寄件者: Tang Lok San <[REDACTED]>
寄件日期: 2026年08月25日星期二 15:18
收件者: tpbpd/PLAND
主旨: Re: S. 16 Planning Application No. A/YL-KTN/1246 - Departmental Comments
附件: AYL-KTN 1246 20260807.pdf

有關漁農自然護理署對 A/YL-KTN/1246 的查詢

Appendix 7 Statutory Plans	Location: D.D. 107 Lot 1292 OZP: S/YL-KTN/11 District: Kam Tin North Zoning: Agriculture	Proposed Temporary Warehouse (excluding Dangerous Goods Godown) with Ancillary Facilities and Associated Filling of Land For a Period of 3 Years		Drawing No.: 7
				For Identification Only Date: 07/08/2026

Responses on DSD's Requirements and RemindersPlanning Application No.: A/YL-KTN/1246Location: Lot No. 1292in D.D. 107Site Area: 647.5 m²Land filling works involved? Yes / NoMaximum increase in formation level: 0.6 mMaximum level difference with adjoining lot: 0 mFilling of pond(s) involved? Yes / NoEstimated size of pond to be filled: NA m³

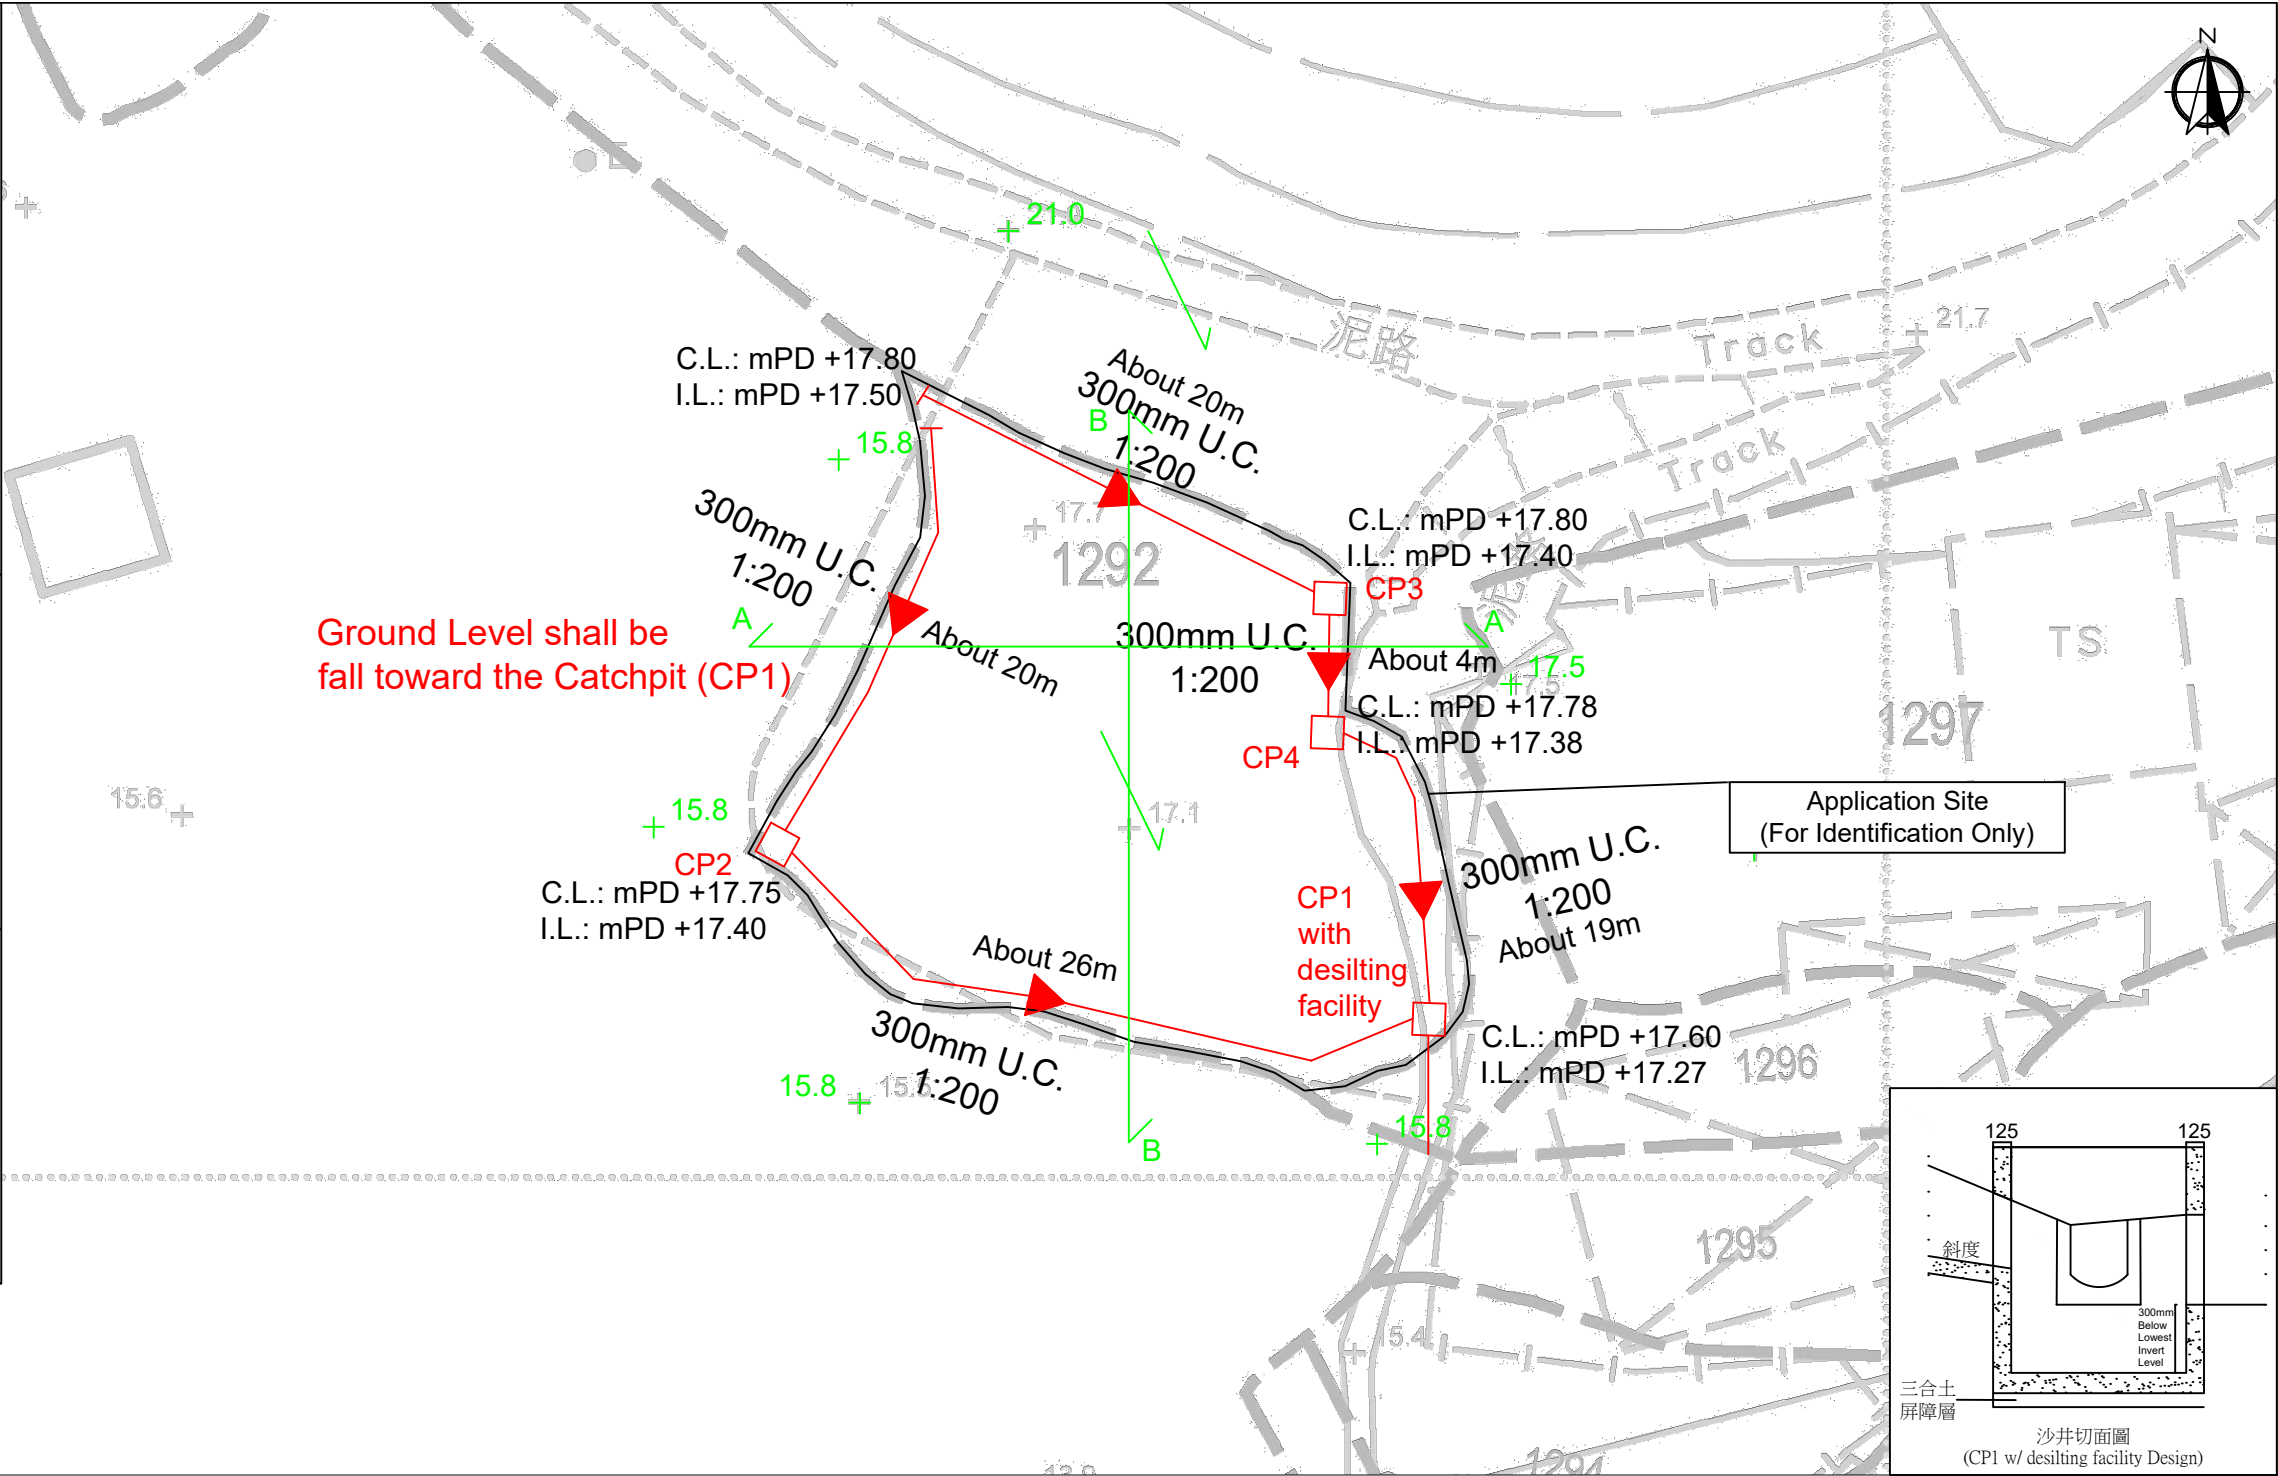
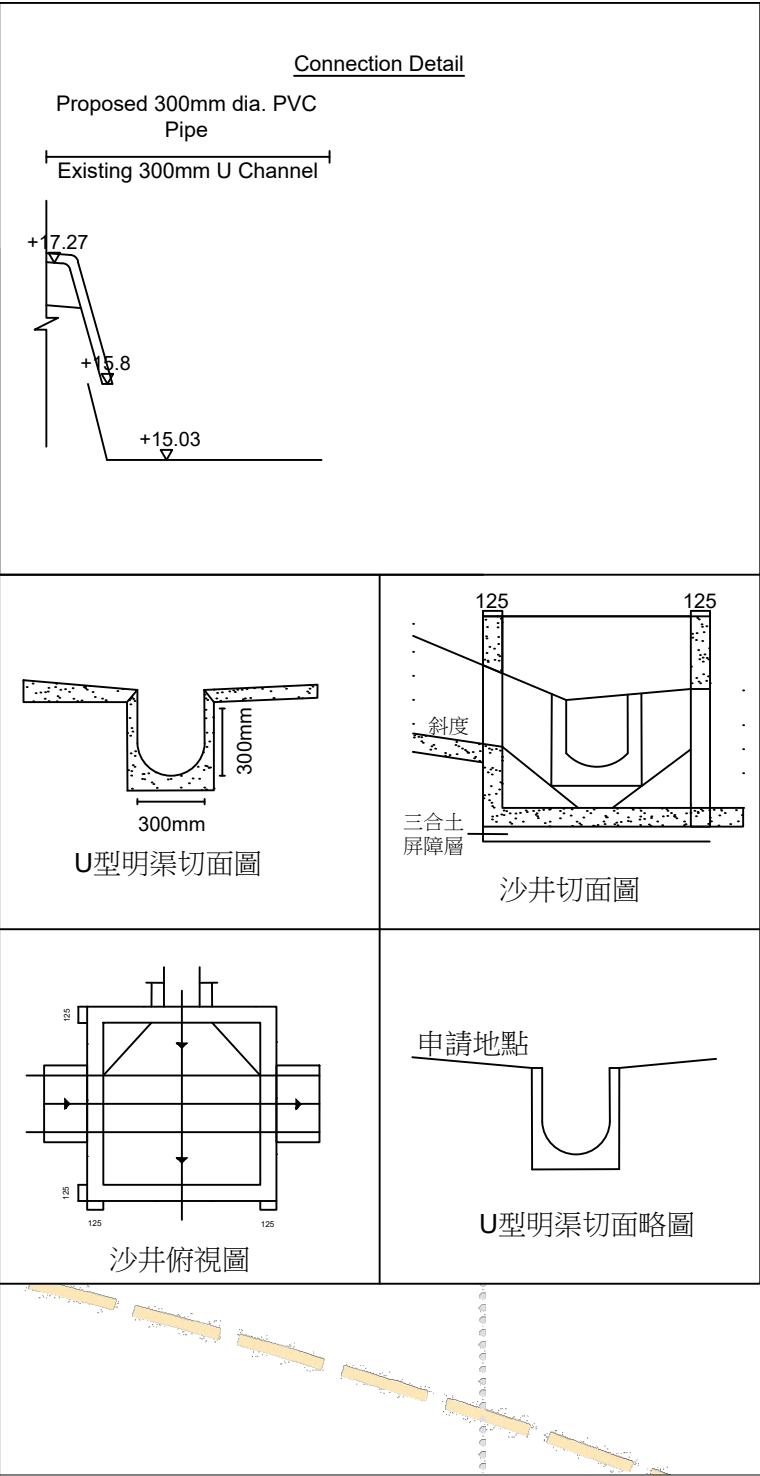
5	Where boundary walls or hoarding are erected, adequate openings should be provided to allow existing overland flow from the adjoining lots to pass through (see Sketch A).	Yes
6	The applicant shall be required to place all the proposed works 3m away from the top of the bank of any existing watercourses or natural streams. All the proposed works in the vicinity of the watercourses should not create any adverse drainage impacts, both during and after construction. Adequate measures should be provided by the applicant to DSD's satisfaction in order to prevent the subject site from being eroded and flooded and to ensure that the capacity of watercourses and the flooding susceptibility of the adjoining areas would not be adversely affected by the proposed development.	Yes
7	The applicant should indicate the proposed and existing ground levels of the application site and ground levels of adjacent areas on the drainage plan.	Yes

8	Cross sections showing the proposed drainage facilities and existing and proposed ground levels of the application site with respect to the adjacent areas should be given.	Yes
9	The proposal should indicate how the runoff (the flow direction) within the site and from the adjacent areas would be discharged to the proposed drainage system.	Yes
10	Sand trap or provision alike should be clearly indicated on the proposed drainage plan and provided before the collected runoff is discharged to the existing drainage facilities.	Yes

11	The applicant should clearly indicate the full alignment of the discharge path from the application site all the way down to the ultimate discharge point (e.g. a well-established stream course/public drainage system).	Yes
12	The applicant should clearly indicate the existing drainage facilities on the proposed drainage plan. Site photos of existing drainage facilities including the discharge point (e.g. existing local village drain and its downstream drainage facilities) should be provided in order to demonstrate the presence and reflect condition of the existing drainage system. Also, the applicant should provide site photo(s) to demonstrate size of the existing drainage facilities.	Yes
13	Cover levels and invert levels of the proposed and existing drainage facilities should be shown on the drainage plan. Invert levels of drainage facilities at the upstream should be higher than that at the downstream. Also, gradients and sizes of the proposed and existing drainage facilities should be shown on the drainage plan.	Yes

1. Adequate opening will be provided around the application site.
2. Catchpit design shall follow CEDD standard drawing No. C2406I.
3. All proposed U-channel and Catchpit must maintain in good shape (i.e. Inspection and maintenance regularly).
4. Grating Cover is provided to reduce the irregular road surface from entering the site.

The Proposal for planning application no. A/YL-KTN/1004 has already included the runoff of this application area.
